Phoenix Ironworks

Condition 20(a) - Noise Impact
Assessment
Eric Wright Construction

Job No: 1044457
Doc ref: 220010-CDL-XX-XX-T-Z-0045251
Revision: ~~P02~~P03
Revision date: ~~23-January-2026~~26 March 2026

Revision ref	Issue date	Purpose of issue / description of revision
P01	14 November 2025	First Issue
P02	23 January 2026	Minor text amendments to executive summary
P03	26 March 2026	Revised following comments received from Manchester City Council

Figure 4-34-3: Predicted Night-time free-field noise levels from road traffic – View from North East

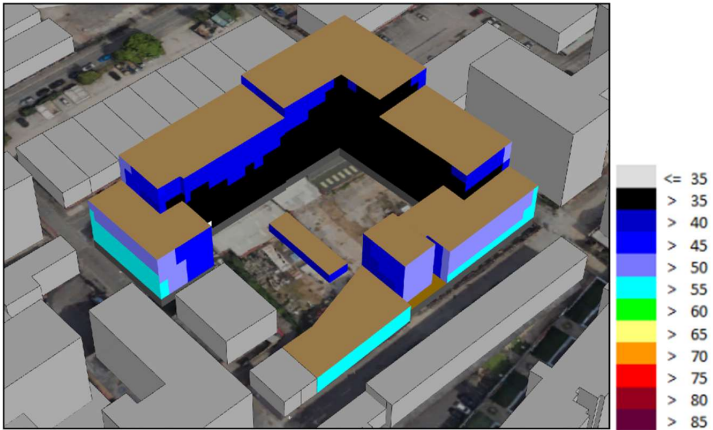
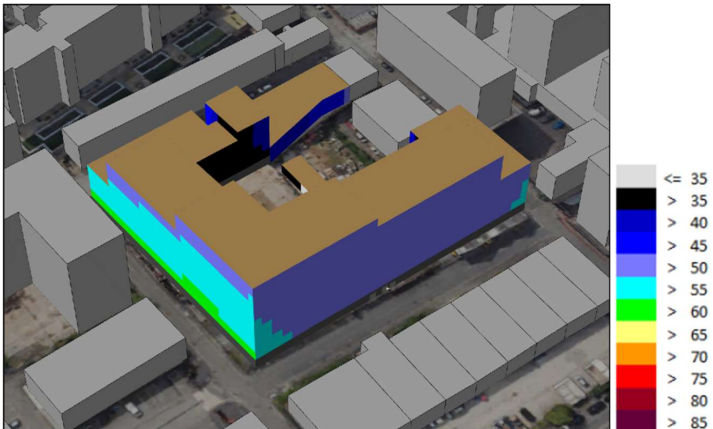
Exceptions to this general condition occur to bedrooms located on the façades of the inner courtyard, where night-time ambient noise levels are less than 50-45 dB $L_{Aeq,T}$ (i.e. the black or darker blue shaded areas depicted in [Figure 4-3](#)[Figure 43](#) and [Figure 4-4](#)[Figure 44](#). In these areas, a partially open window will result in external noise ingress being less than 38-35 dB $L_{Aeq,T}$ in the bedrooms at night.

As such, internal ambient noise levels in bedrooms at night will be less than 40 dB $L_{Aeq,T}$ in all instances and will therefore comply with the noise requirements for Approved Document O.

Figure 4-7. Time history plot of daily daytime overheating condition to Poland Street Plot 03.105

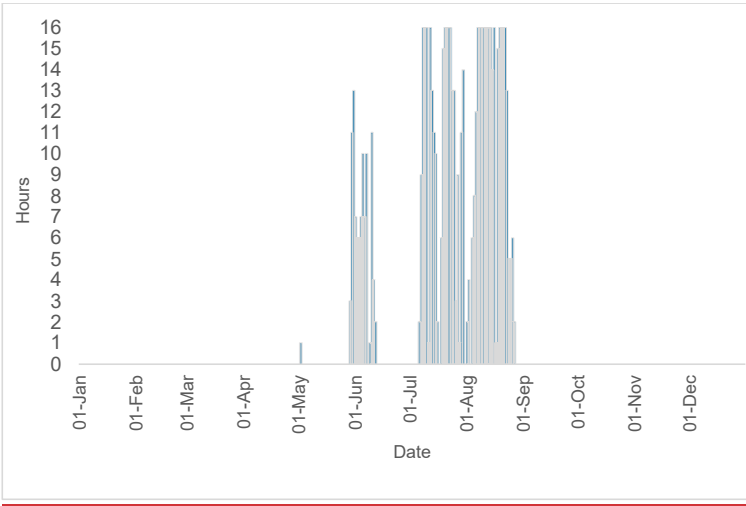
~~Radium Street~~ — 24%, [Table 4-343 details the predicted daytime overheating hours for the worst-case affected habitable plot \(Plot 03.105\) on the Poland Street elevation most exposed to road traffic noise \(up to 49 dB \$L_{Aeq,T}\$ internally during the day\). These represent periods during which windows may be opened for thermal comfort. A time history plot of number of daytime overheating hours is also provided in Figure 4-747.](#)

The results indicate that overheating conditions are limited to the summer period, with no overheating predicted between September and April. The occurrence of overheating is therefore confined to four months of the year, primarily during the peak summer months of July and August.

Across the year as a whole, a total of 661 hours of overheating are predicted, which equates to approximately 11.3% of daytime hours annually. Outside of the peak summer months, the frequency of overheating is comparatively low, with May and June averaging less than 2.5 hours per day.
